PCN-20190715 TE0745-02-* SPI Flash Change

Company	Trenz Electronic GmbH
PCN Number	PCN-20190715
Title	TE0745-02-* SPI Flash Change
Subject	BOM change
Issue Date	2019-07-16

This change affects Trenz Electronic TE0745-02 SoMs: TE0745-02-*

#1 Change SPI Flash from N25Q512A11G1240E to MT25QU512ABB8E12-0SIT

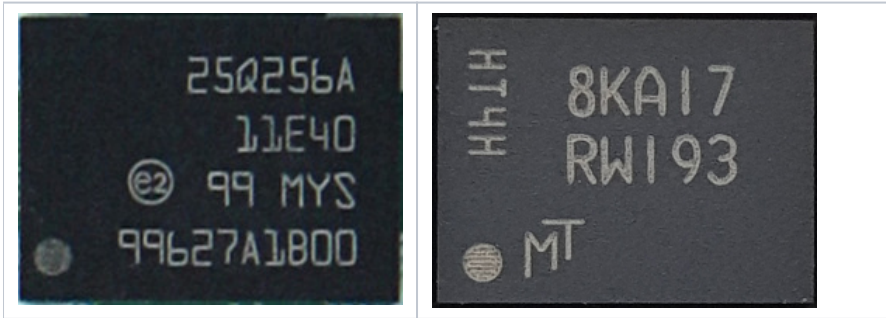
Reason: N25Q512A11G1240E became obsolete.

Impact: None. Both have same JEDEC ID BB20h and manufacturer ID 20h.

Locate Flash (U14) on bottom side of PCB:
